Re: 339 West Gorham Street: Oliv Madison

Attached is a minor amendment packet for the Oliv Madison Project. These changes address some program elements (expanded amenity), design refinements, and adding solar to the project. The packet illustrates the changes between the Original SIP document and the proposed amendments. The site plan review/building permit set elevations are also included for reference to show what was approved with the building permit.

UDC MINOR REVISIONS

ōliv MADISON 339 W GORHAM STREET

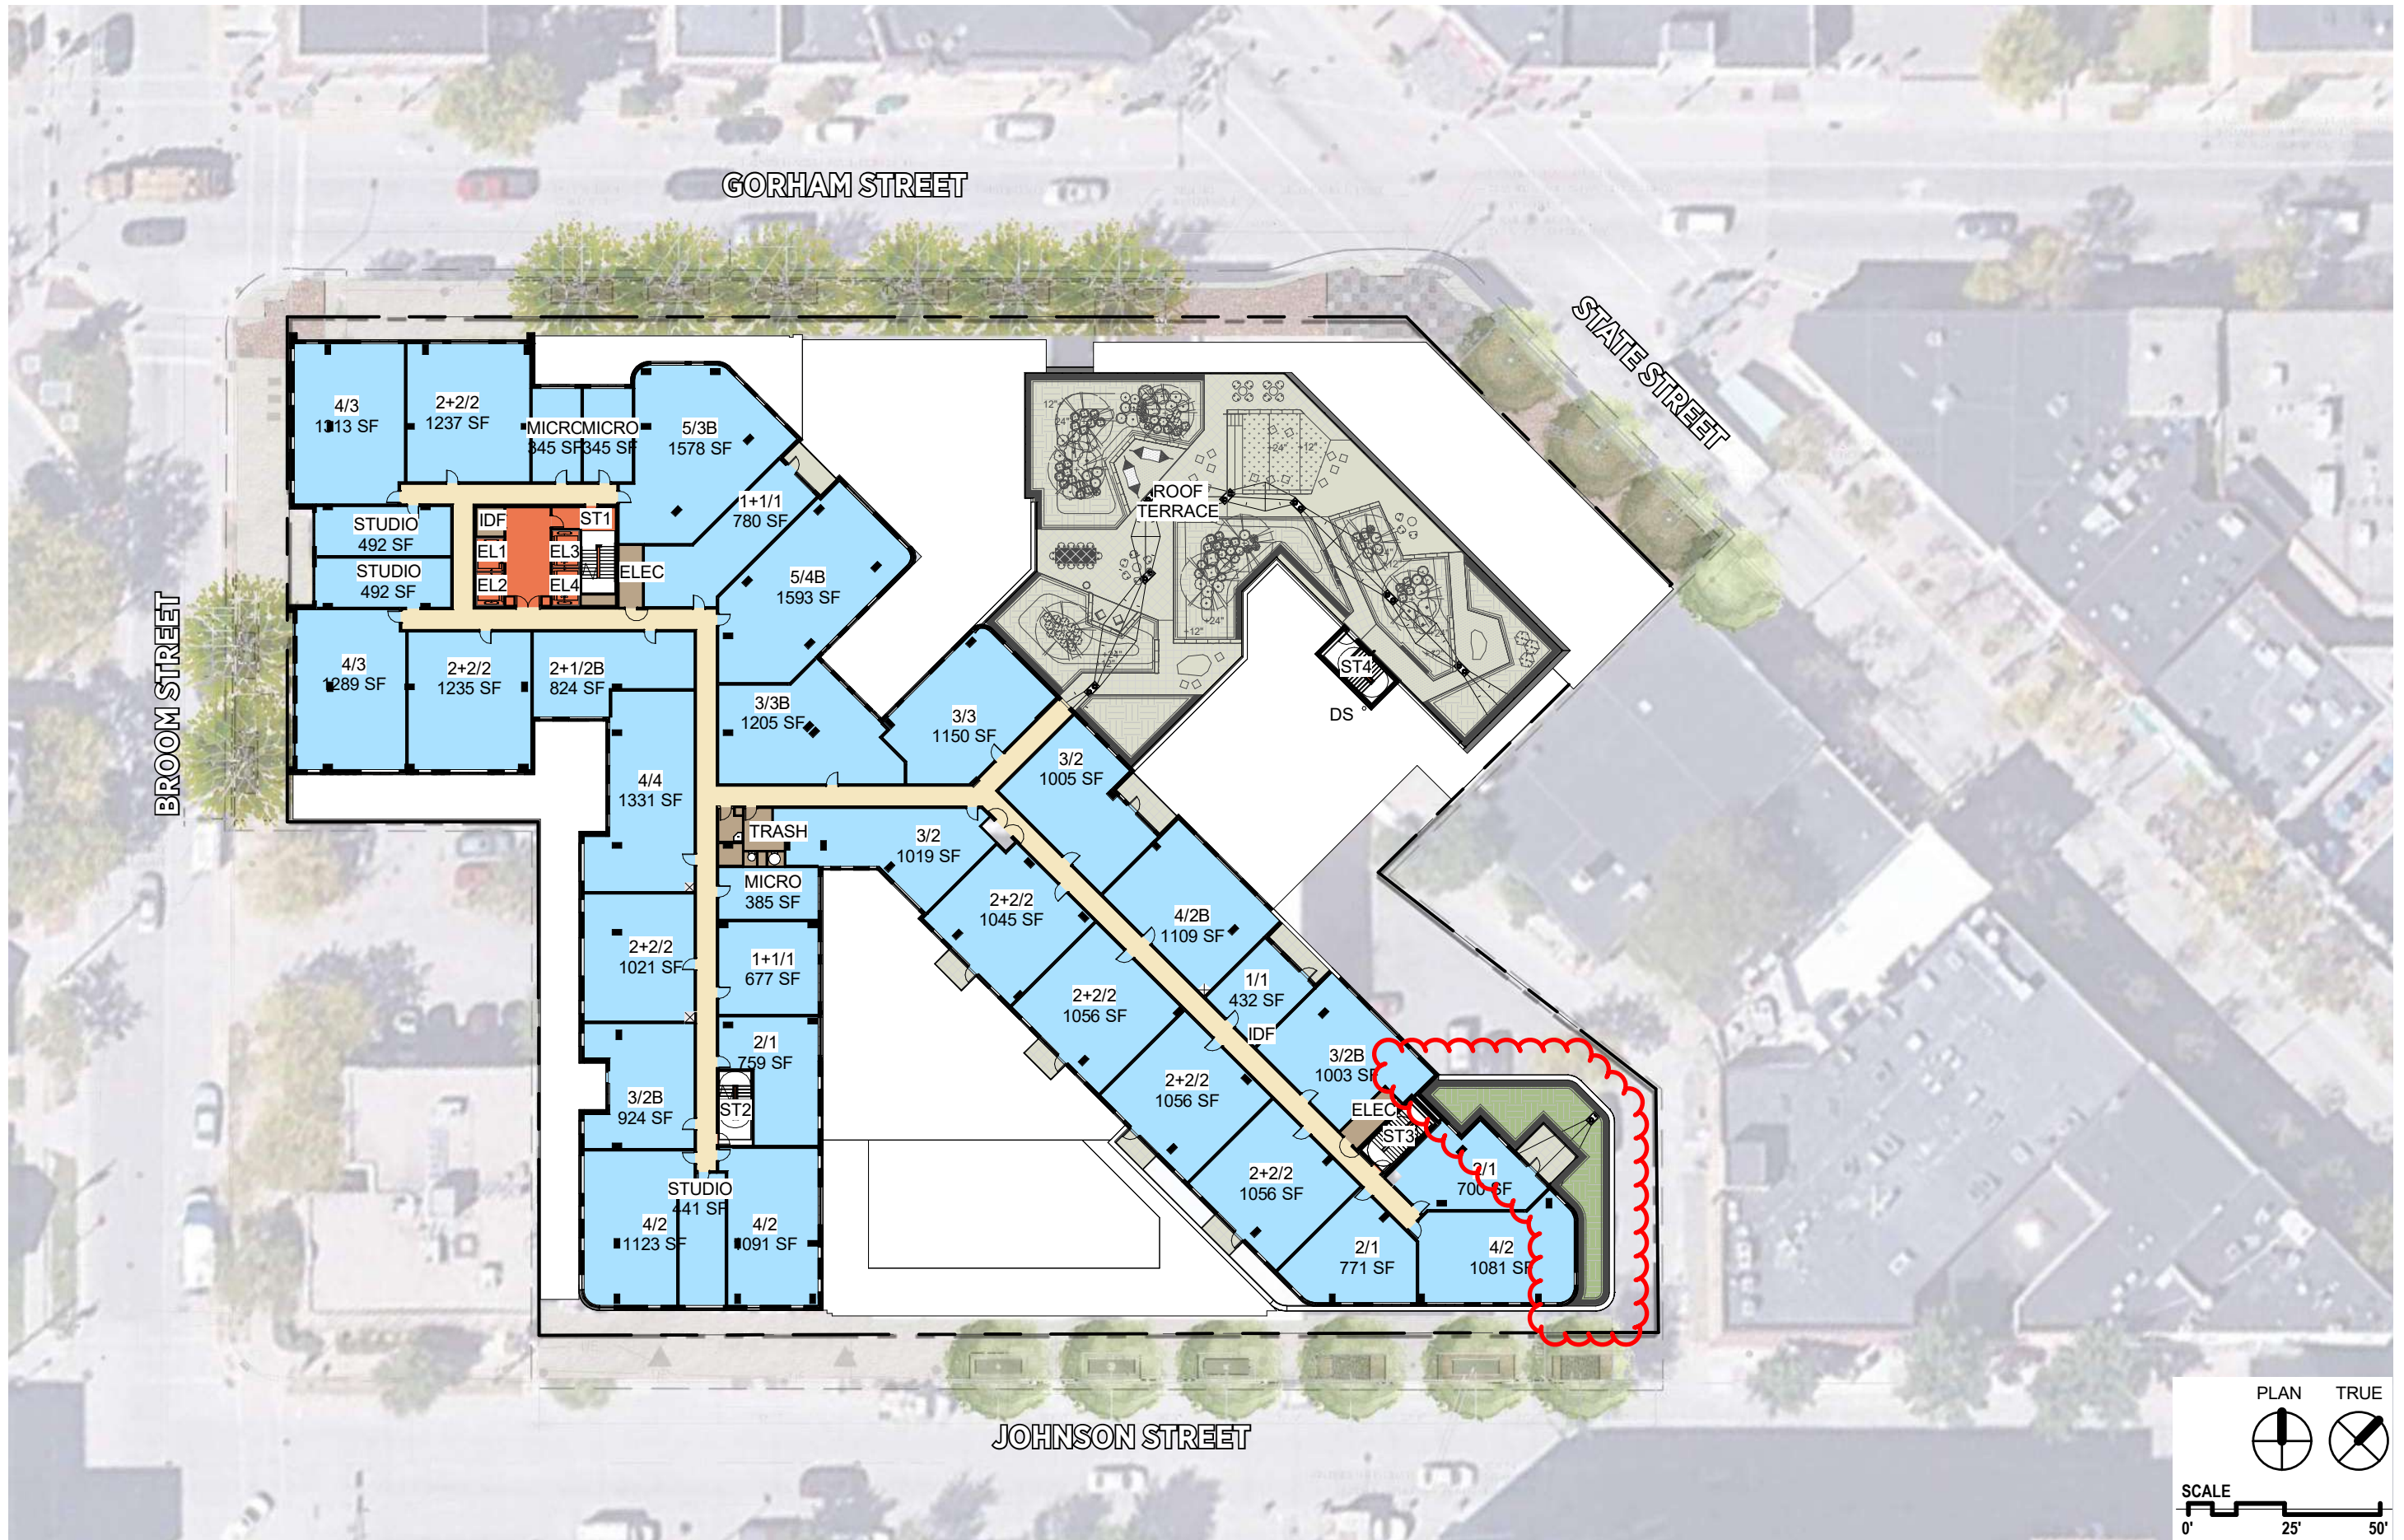
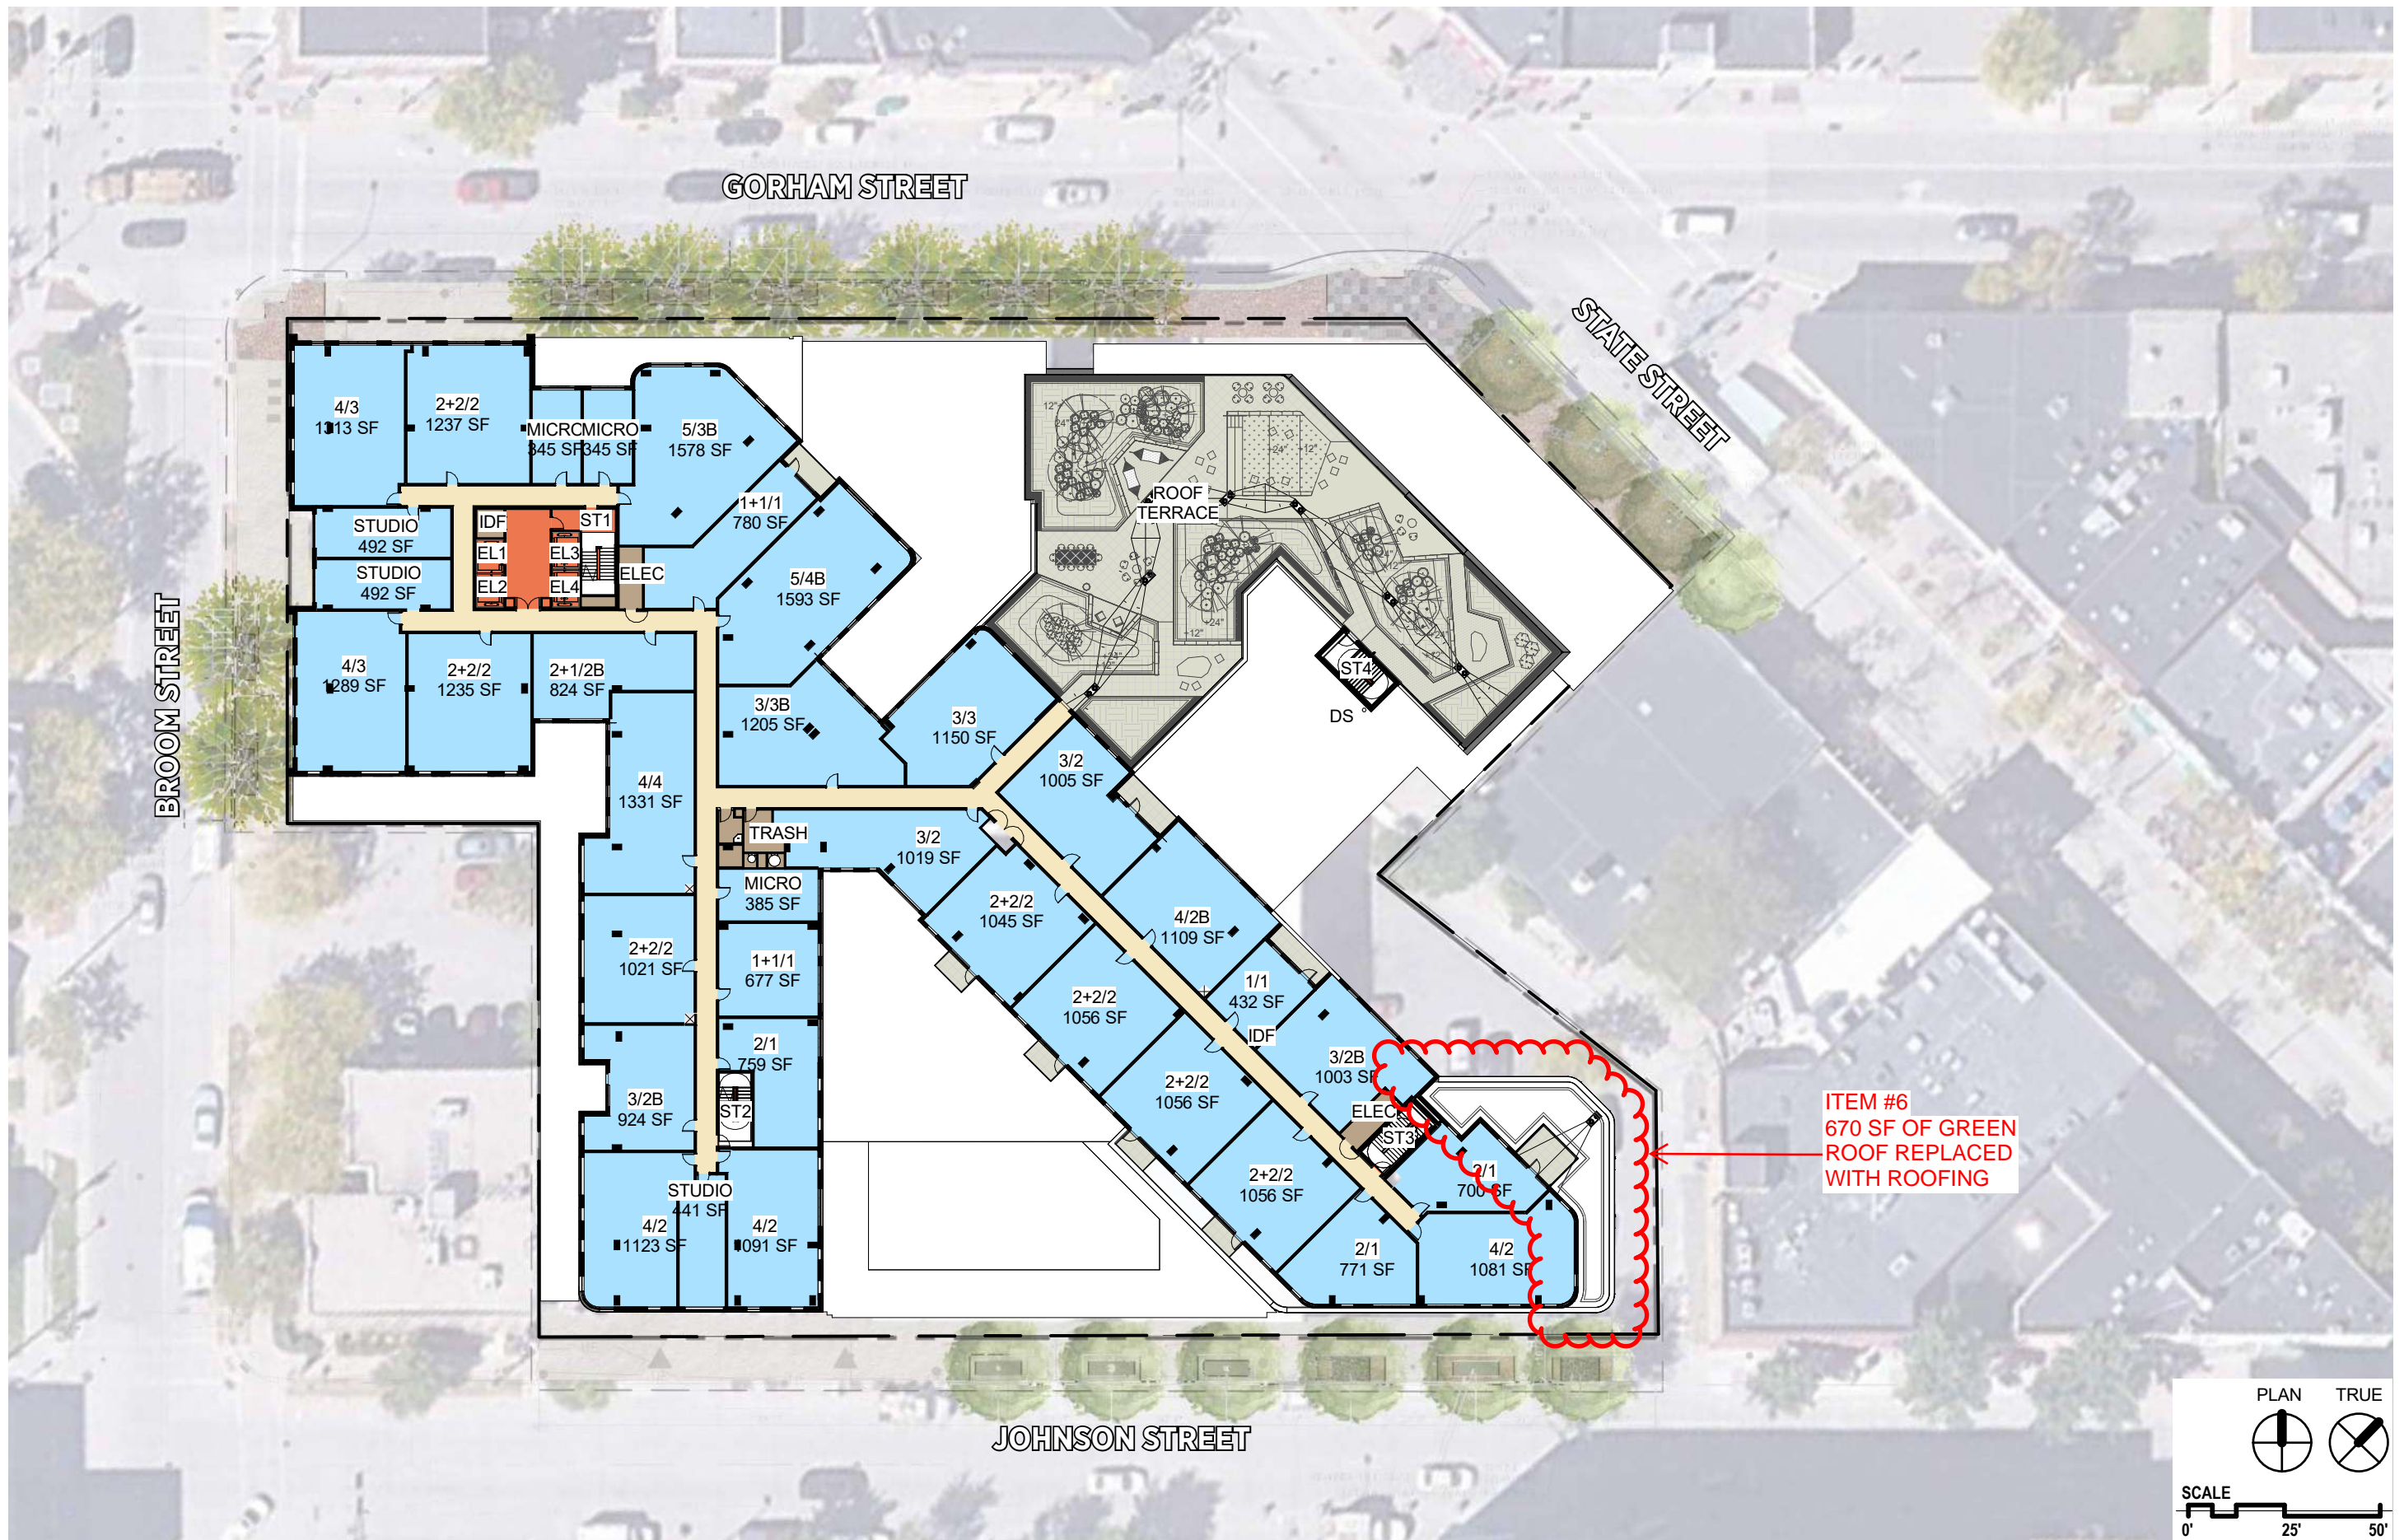
- Item 6. Added Solar Panels and green roof modifications (A45, A46, A47, A49, A51): Reduction of select green roofs for proper maintenance access. The areas deleted required maintenance access through tenant units. The removal of these select green roofs provides the financial ability to add solar panels on the roof. The project added 8,485 SF to dedicate to solar panels.

- i. Note on item 6: The project will still almost double the minimum green roof requirement for stormwater management. 6,600 SF was required. 14,209 SF was provided in approved set. The current proposal includes 11,613 SF of green roof.

ITEM #6
87 SF OF GREEN
ROOF REPLACED
WITH ROOFING

ITEM #6
670 SF OF GREEN
ROOF REPLACED
WITH ROOFING
